Planning Commission Meeting Agenda

Tuesday, July 14, 2026 at 6:00 PM

Site Plan- True Rail

The applicant is requesting approval of a site plan located off S. Main Street for True Rail Enterprises. This is a site development plan for a rail yard. The property is approximately 62.16 acres and is zoned IL (Light Industrial). This project will create a building that is 112,500 square feet in total with space dedicated to both office and warehouse. Approximately 25.45 acres of land will be disturbed area.

SHEET **C2.0**

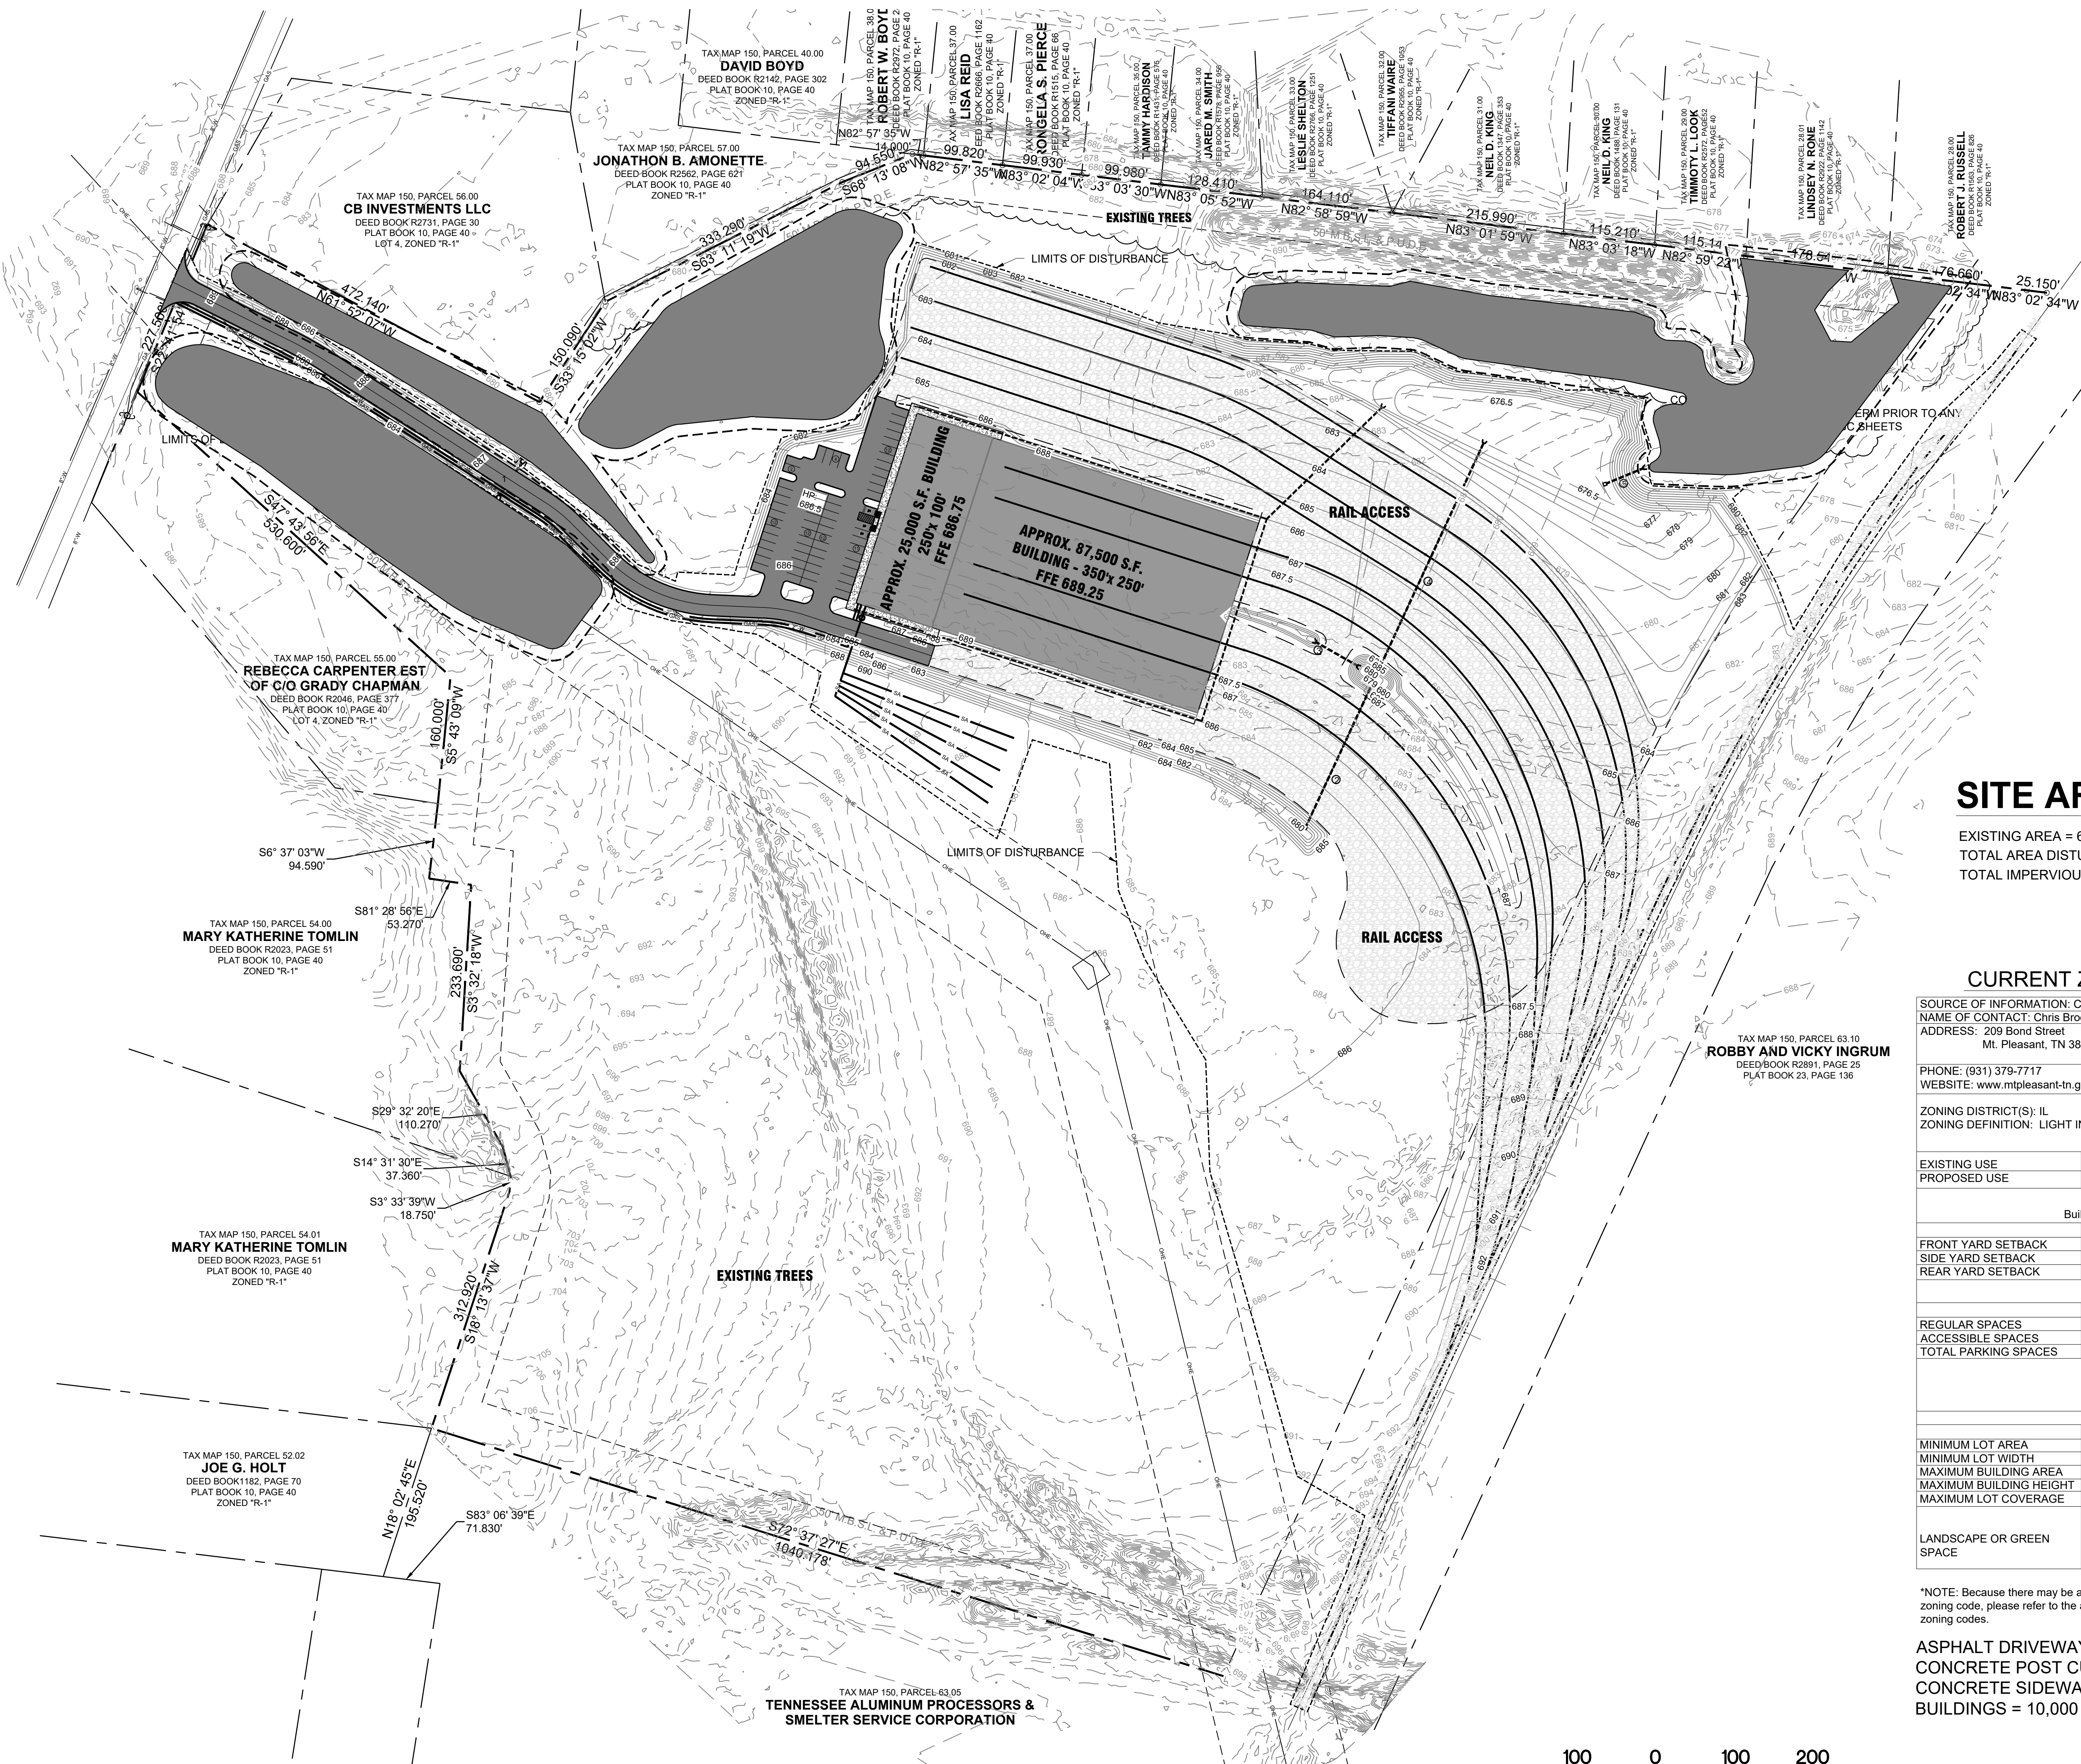
Sheet C2.0 shows the building as being split with 25,000 square feet dedicated to office space and 87,500 square feet dedicated to warehouse/distribution. The Stormwater Prevention Plan has the same square footages in its site description. However, on sheet C2.0 under the Current Zoning Information, it has the office space called out as 10,000 square feet and the warehouse space as 102,500 square feet. These differences would affect the required parking spaces.

The plan proposes a total building size of 112,500 square feet. The plan shows 10,000 square feet of proposed office with the remaining square footage for the purpose of servicing the rail cars. We are classifying this as “warehousing” for the purposes of calculating the parking requirements. According to Section 14-1102 *Off-Street Parking and loading standards*, the office portion of the plan that totals 10,000 square feet requires 3 parking spaces per 1,000 square feet of gross floor area, meaning this would require 30 parking spaces. The warehouse portion of the plan is 87,500 square feet and requires 1 parking space per 1,000 square feet of gross floor area, meaning that this would require 88. This would require 118 total parking spaces including 5 handicapped spaces. Some sheets refer to the size of the office as 25,000 square feet. If the office portion of the building is 25,000 square feet and the warehouse portion is 87,500 square feet then 163 parking spaces would be required.

An option that could alleviate a portion of the parking requirement is Section 14-1102 *Off-street parking and loading* subsection E. *Land banked future parking* of the Zoning Ordinance. This would allow the planning commission to permit up to 25% of the required parking spaces through the site plan review process. The following standards must be met to allow this:

Another factor to consider is that depending on the use that is classified for the site, parking requirements may be based on number of employees. We recommend adding the number of employees to the site plan.
